**FINAL DRAINAGE REPORT
FOR
STERLING RANCH EAST FILING NO. 1**

November 2022

[See comment letter also.](#)

Job no. 2183.30
PCD File # SF

DETENTION BASIN STAGE-STORAGE TABLE BUILDER

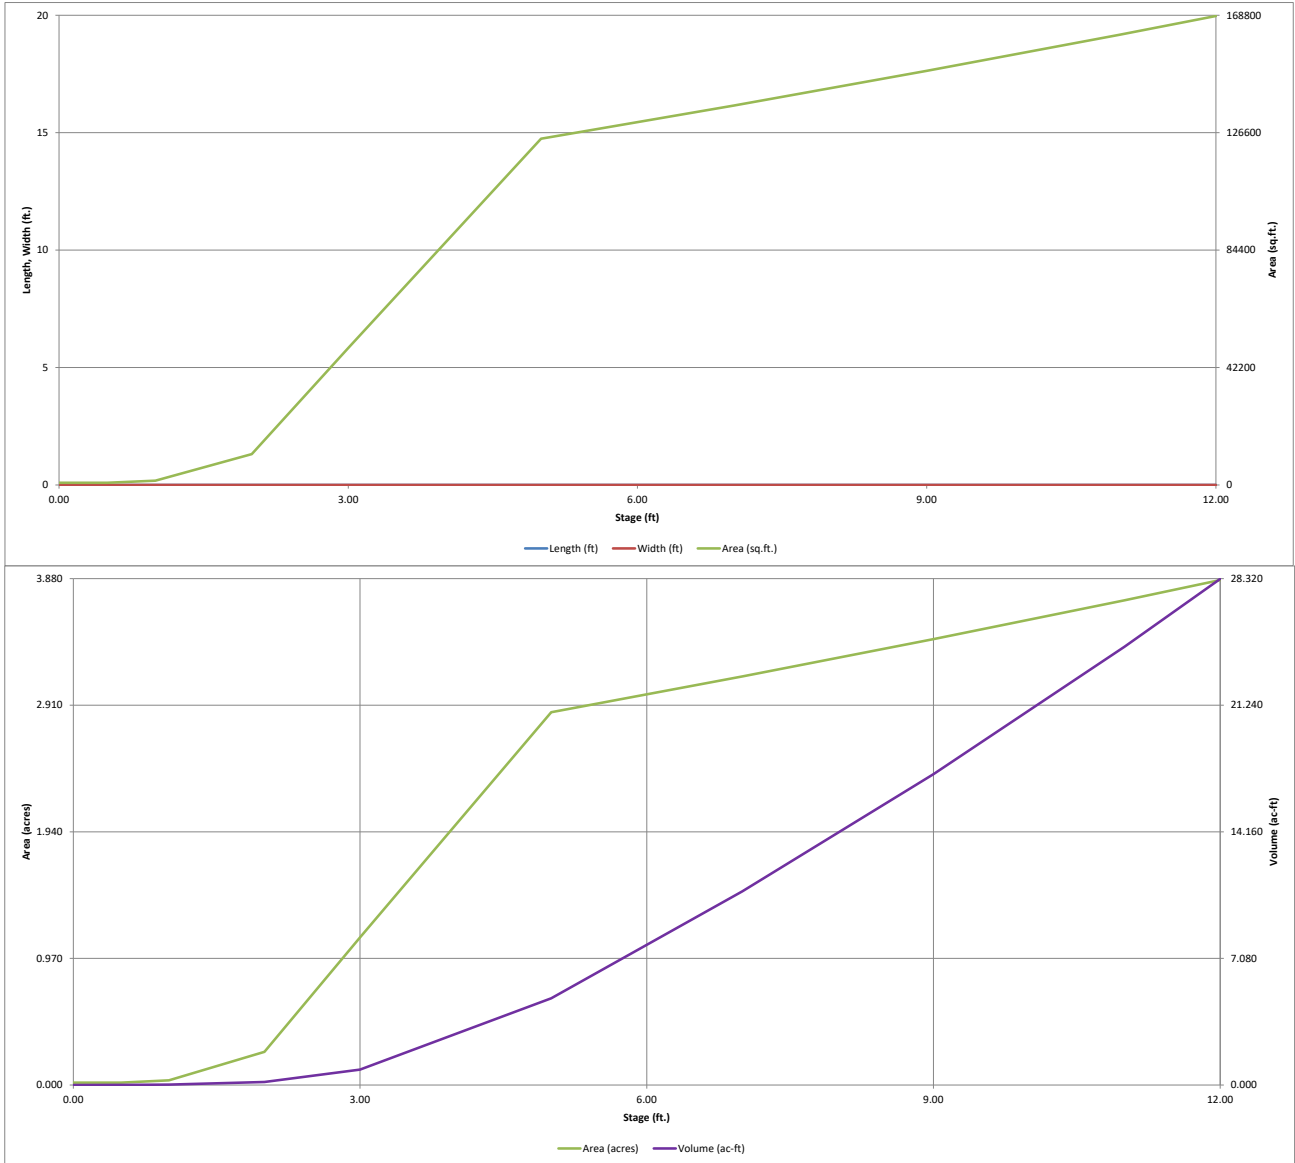
These will be updated with correction to Type A soils

STERLING RANCH EAST FILING NO. 1			
FINAL DRAINAGE REPORT			
TRIBUTARY AREA TO PROPOSED POND 14A			
DESIGNED BY	MAL	SCALE	DATE 10/27/22
DRAWN BY	MAL	(H) 1" = 250'	SHEET 1 OF 1
CHECKED BY	(V) 1" = N/A	JOB NO.	1183.30

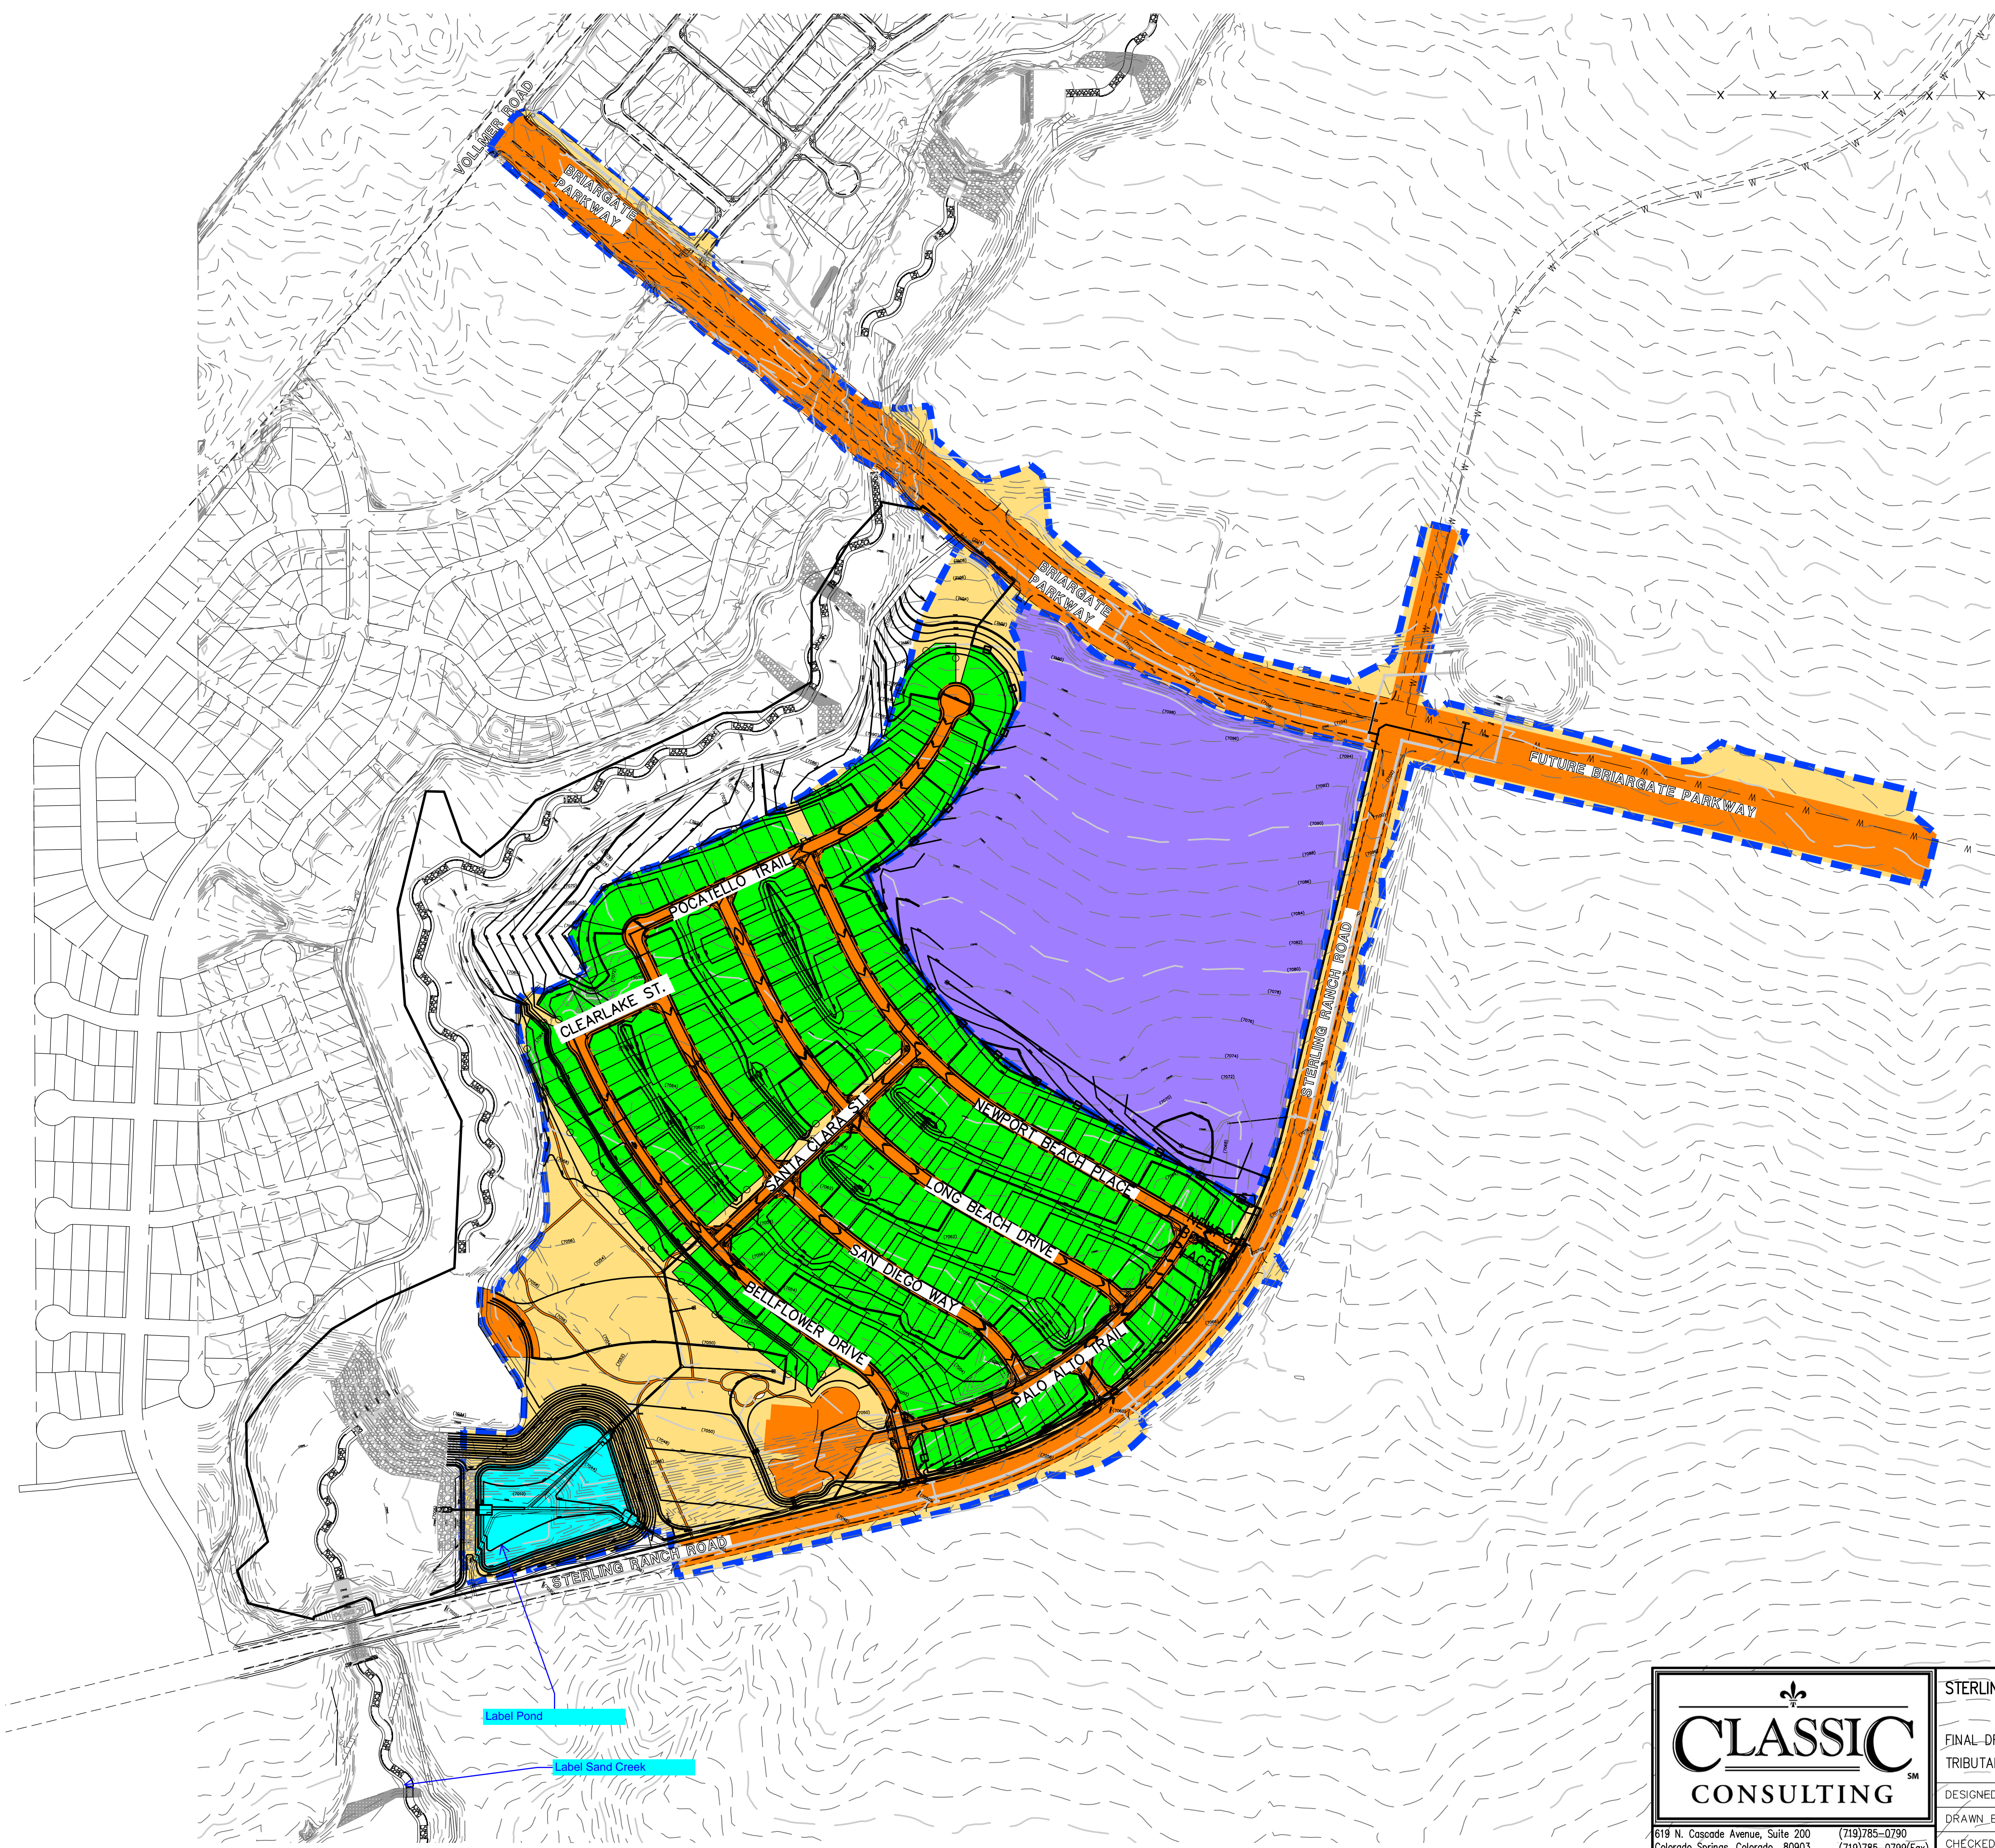
This color needs to be included in legend

Please also include the "Water Quality Treatment Plan Map" that was included with the Drainage Report on SP224.

STERLING RANCH EAST FILING NO. 1			
FINAL DRAINAGE REPORT DEVELOPED CONDITIONS DRAINAGE MAP			
DESIGNED BY	MAL	SCALE	DATE 11/04/22
DRAWN BY	MAL	(H) 1"= 100'	SHEET 1 OF 5
CHECKED BY	(V) 1"= N/A	JOB NO.	1183.30

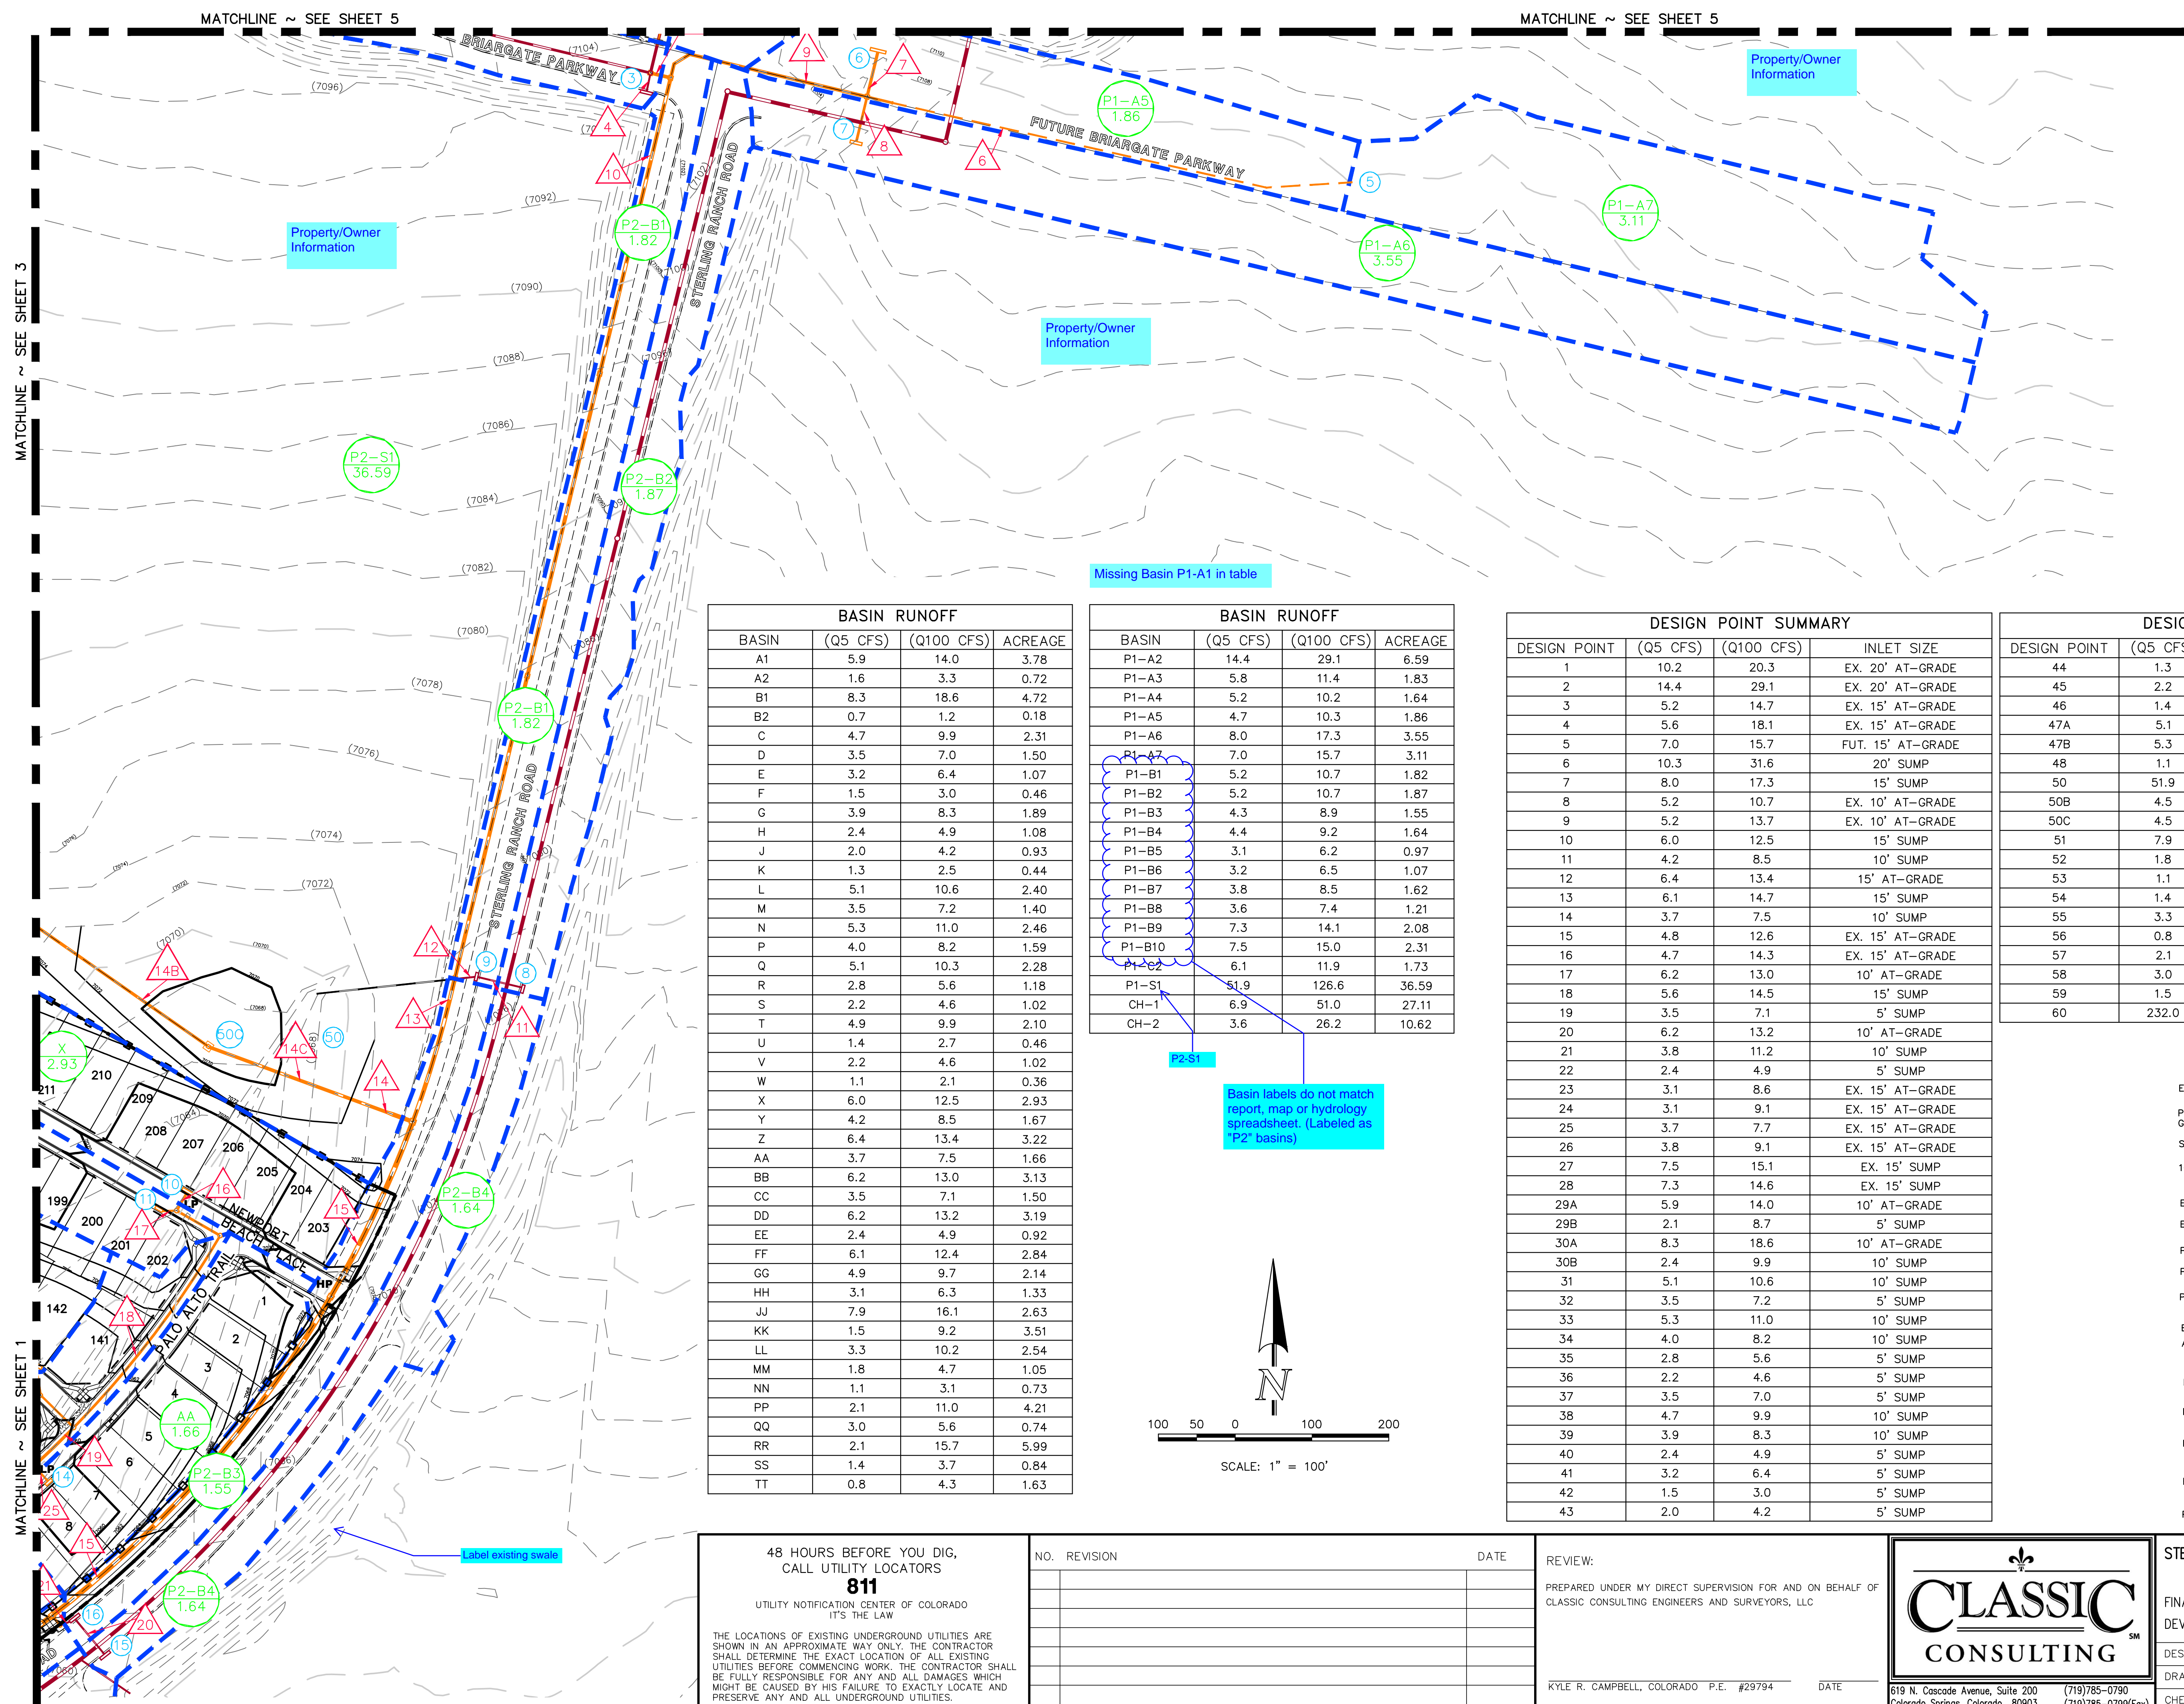
This pipe lateral or inlet were not discussed in report. Break Basin LL into 2 separate basins so inlet/pipe can be added into inlet and pipe design spreadsheets accurately.

Show and label temporary downstream detention/water quality facility mentioned in report

Provide keymap

Include drainage arrows on map to indicate flow directions

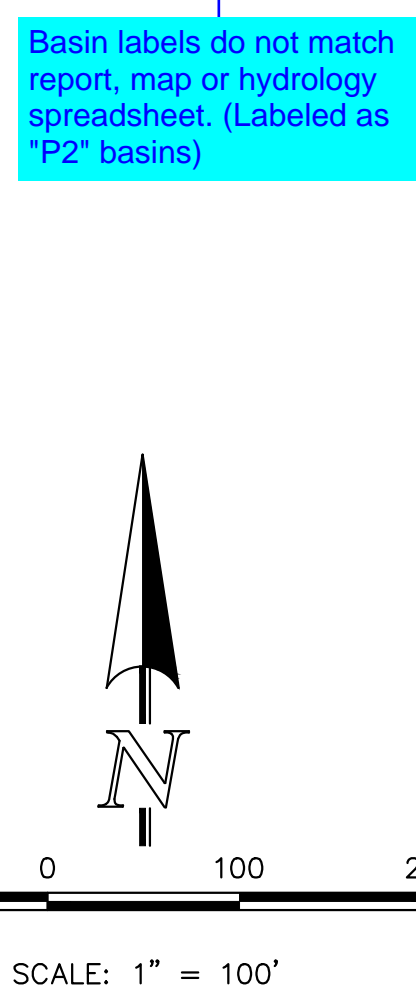
Missing Basin P1-A1 in table
